TO: Wayne Hedberg, Permit Supervisor  
FROM: David W. Darby, Geologist *DWD*  
RE: U. S. Fuel Company, Skyline Mine, Underground Mine  
Plan Modification, ACT/007/005, Folder #3, Carbon  
County, Utah

MINOR MODIFICATION TO  
MINING PLAN APPROVED BY  
BUREAU OF LAND MANAGEMENT

We have discussed with Jeff Clawson of your office our plans to first mine the 1R1W panel of Mine No. 3. We hereby request approval of a minor modification to our mine plan which would allow us to begin first mining in the panel by January 6, 1986.

DIAGRAM 1

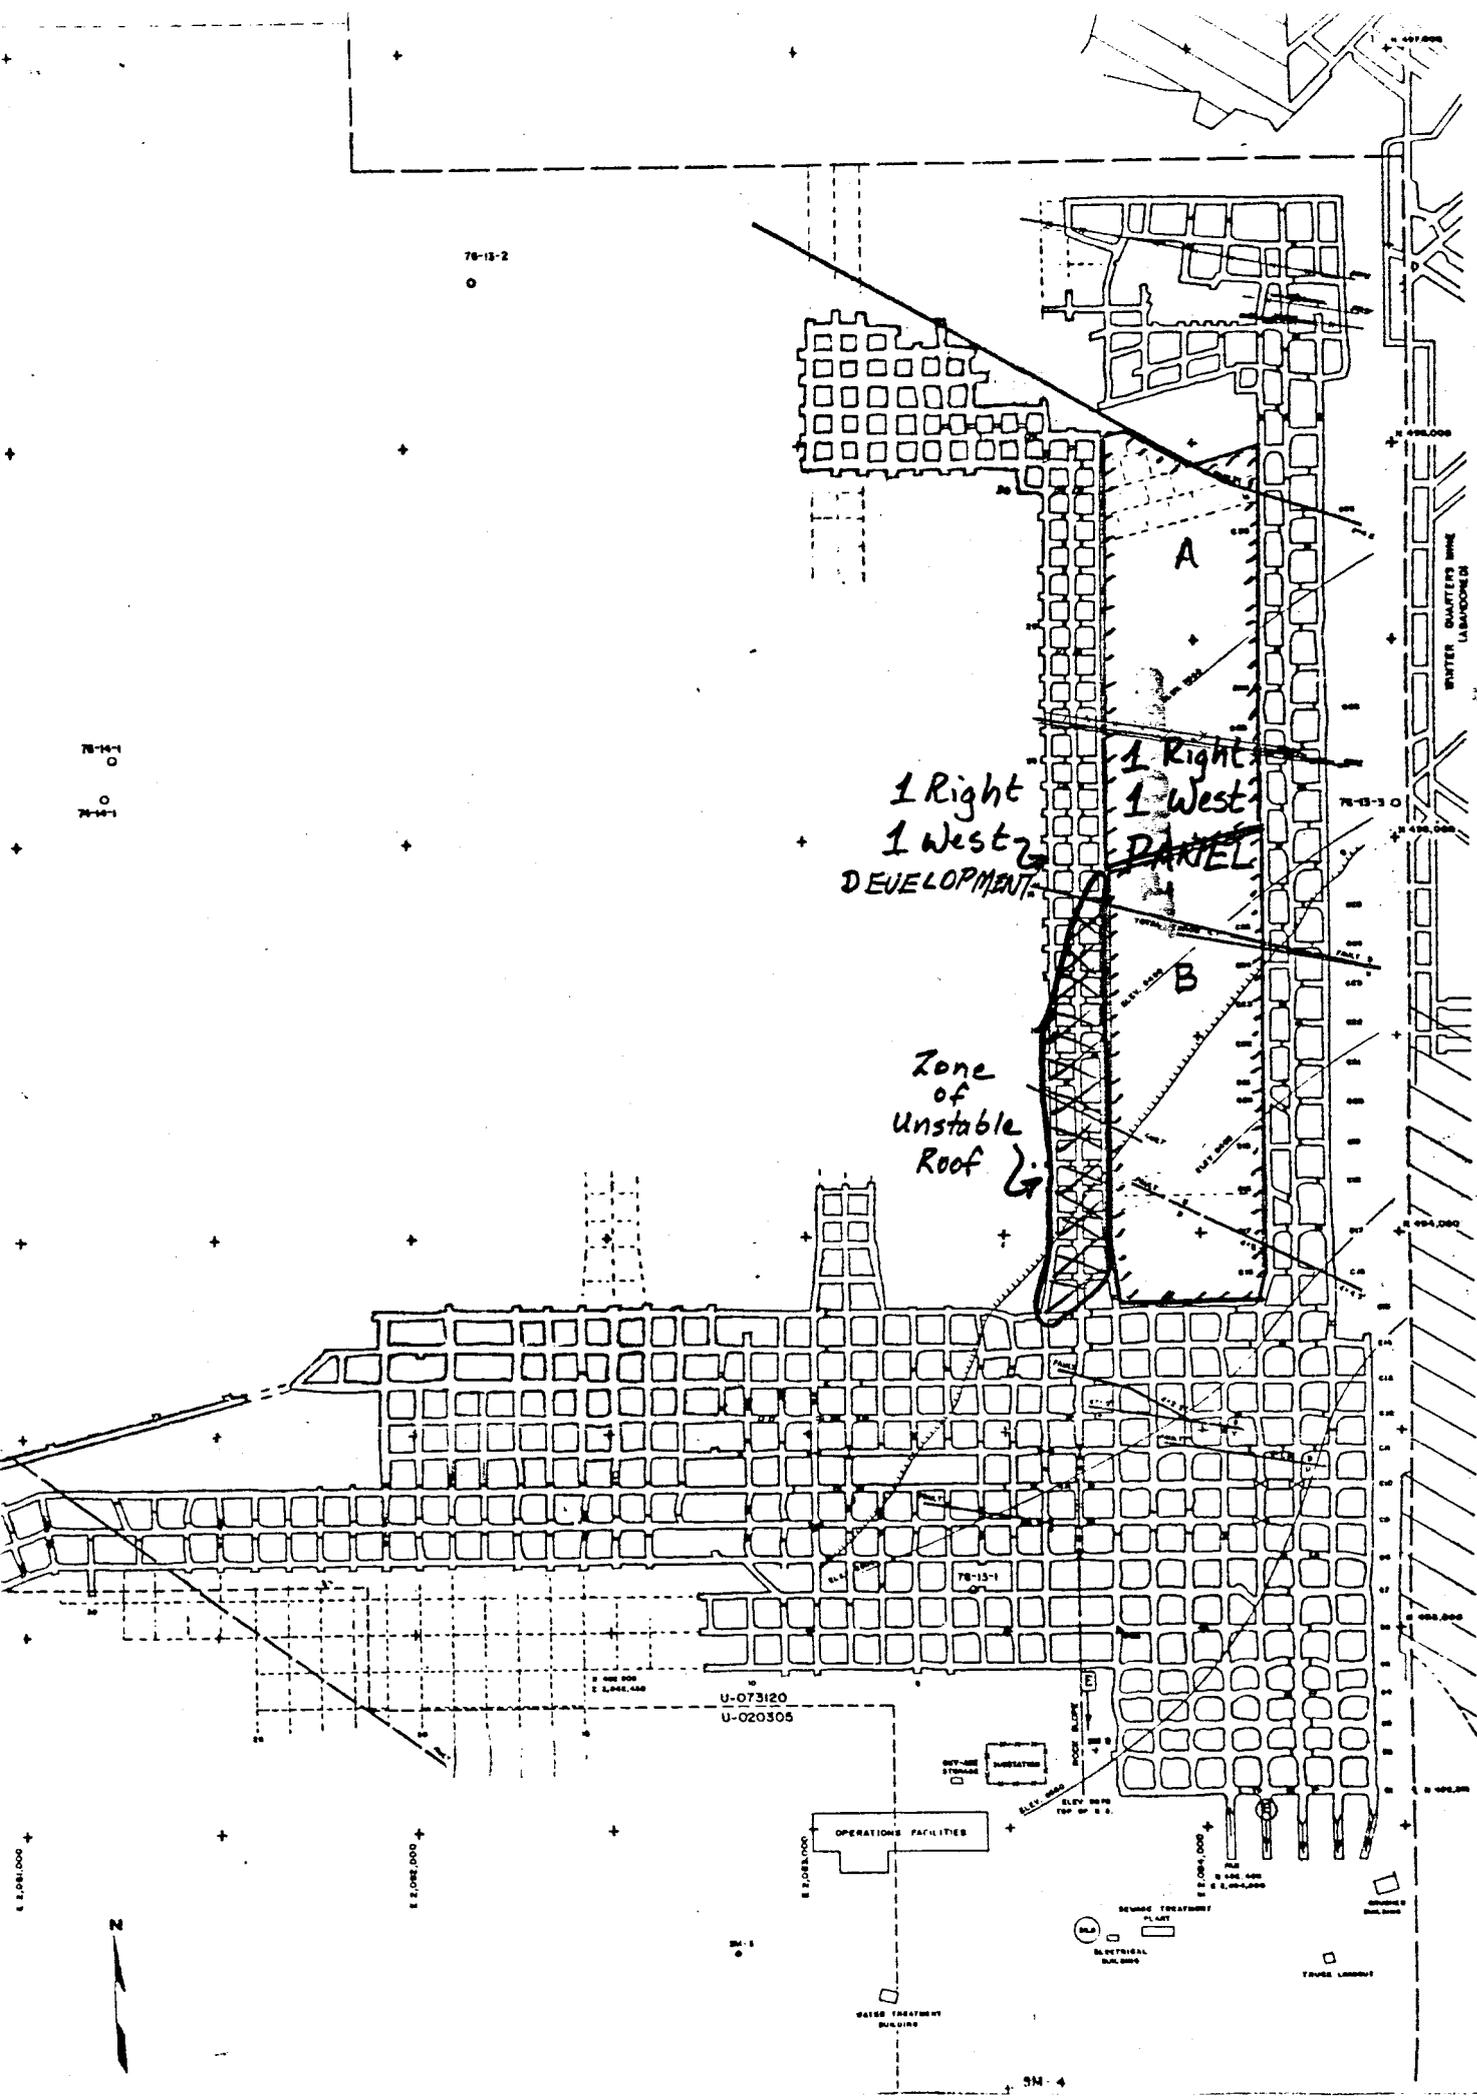
Although conditions within the panel may warrant changing pillar sizes during the course of mining, this time we plan to leave pillars of two different sizes in the panel. The attached map shows two zones. In Zone A we plan to mine approximately 39 x 42 foot pillars (diagram 1) and in Zone B we plan to mine approximately 42 x 47 foot pillars (diagram 2). The entries and crosscuts will be mined 19 to 20 feet wide. Slightly larger pillars are planned for Zone B to enable us to align panel rooms with crosscuts in the 1R1W development entries, thus minimizing exposure of mine personnel to the adverse roof conditions in the area.

This modification can be approved with no changes or conditions.

This minor modification is therefore approved as proposed in your submittal dated December 20, 1985.

# DIAGRAM 3

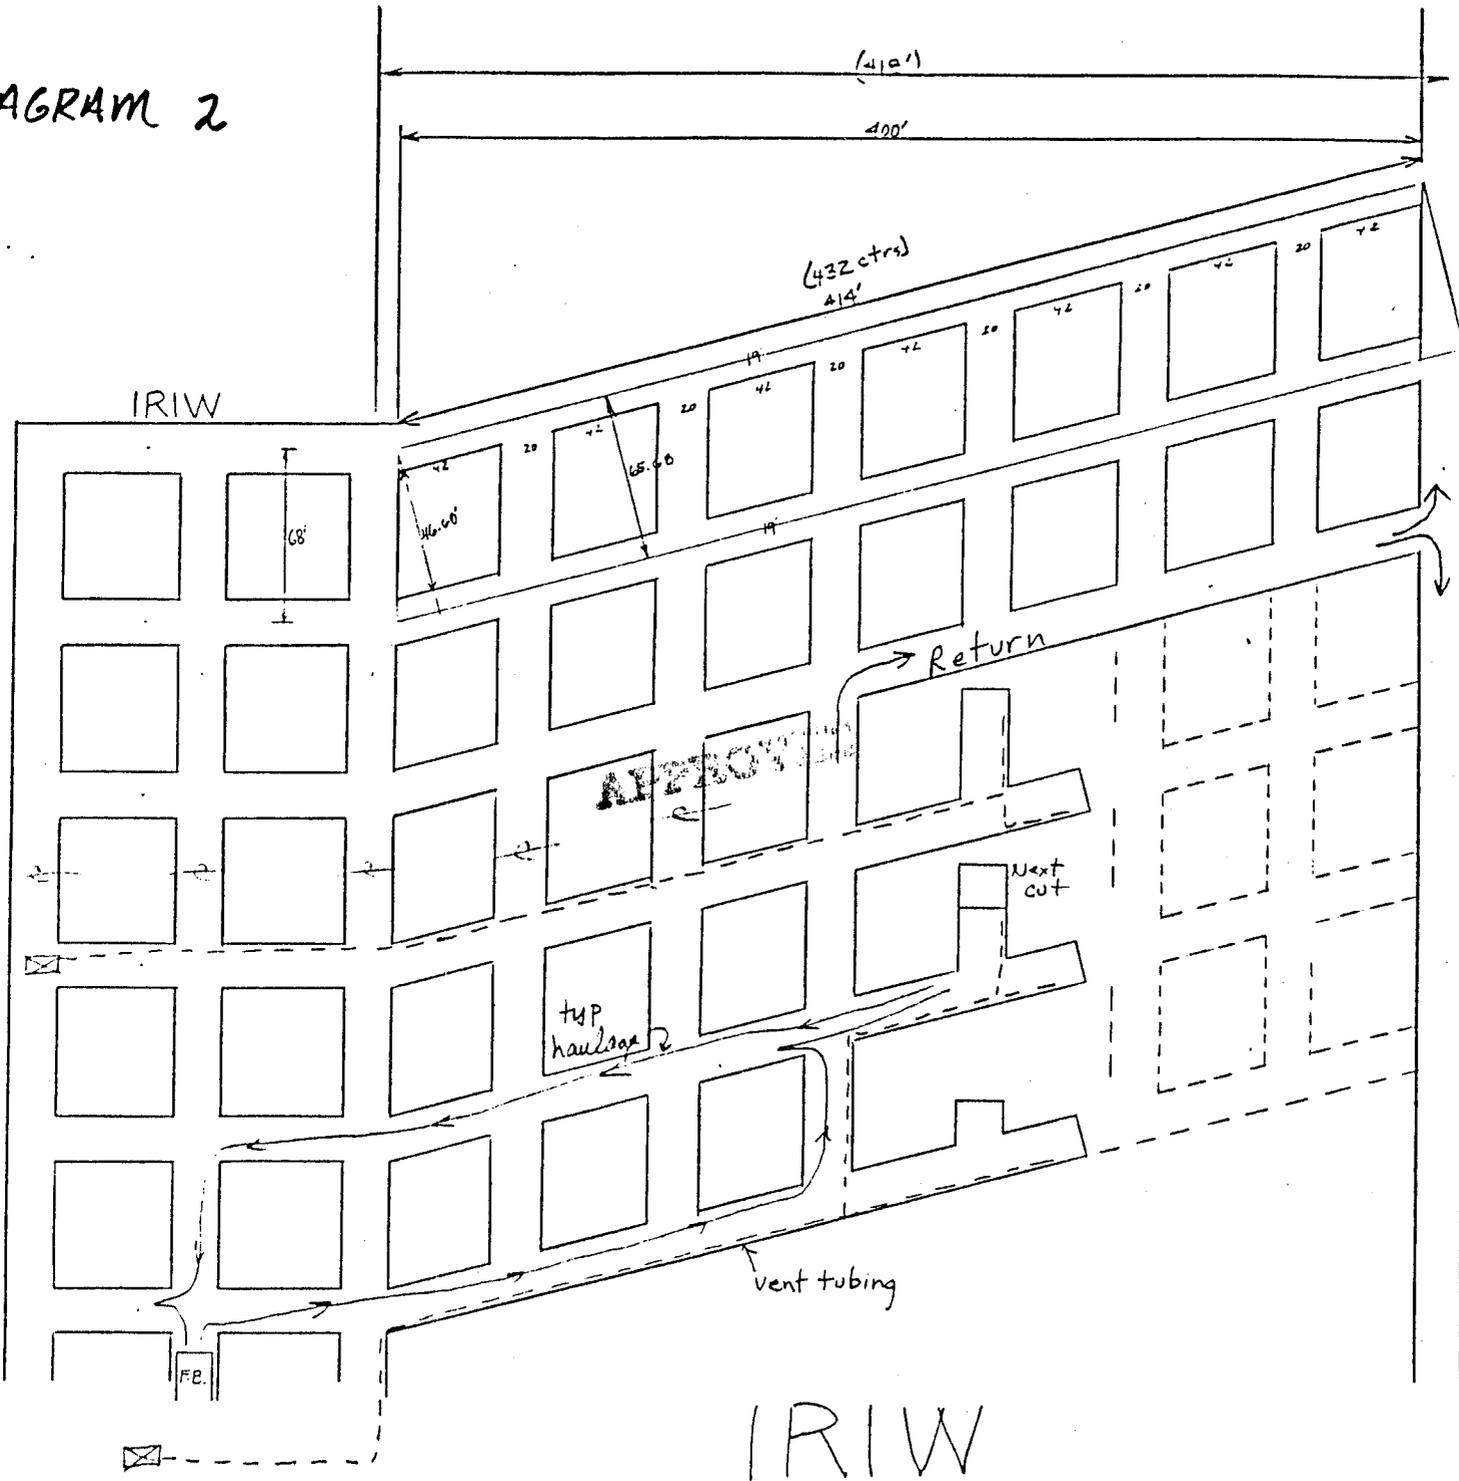
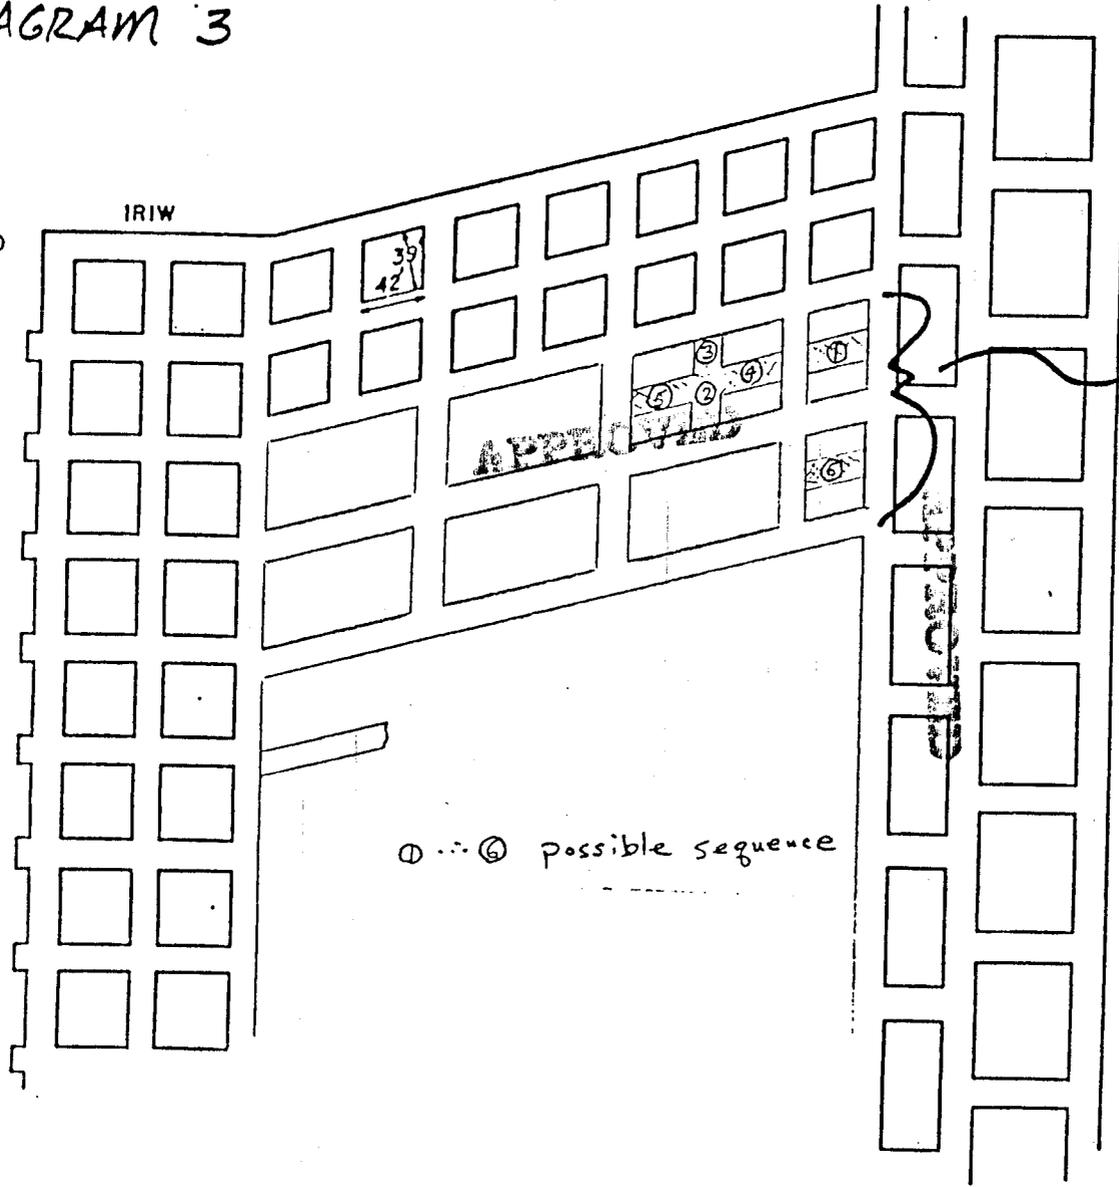
During initial mining of the panel, we also plan to test two to four rows of yield pillars (diagram 3). At the present time we don't know their exact size, but they will most likely be on the order of 20 feet by 40 feet. If, after the test, it appears that yielding pillars can be mined safely and efficiently within the panel, we plan to use pillars of this size for the remainder of the panel.

The adverse roof and rib conditions in IR1W described in your letter are well documented and have been verified by Jeff Clawson, Mining Engineer, of this office. Calculations show that recoverability by the proposed method, first mining only of rooms and entries on 59' X 62' and 62' X 67' centers, should exceed 50 percent for this panel. Given the present conditions this is acceptable. It is also believed that this panel will be a good place to experiment with yield pillar design, which may help to achieve greater productivity and recoverability in the future.
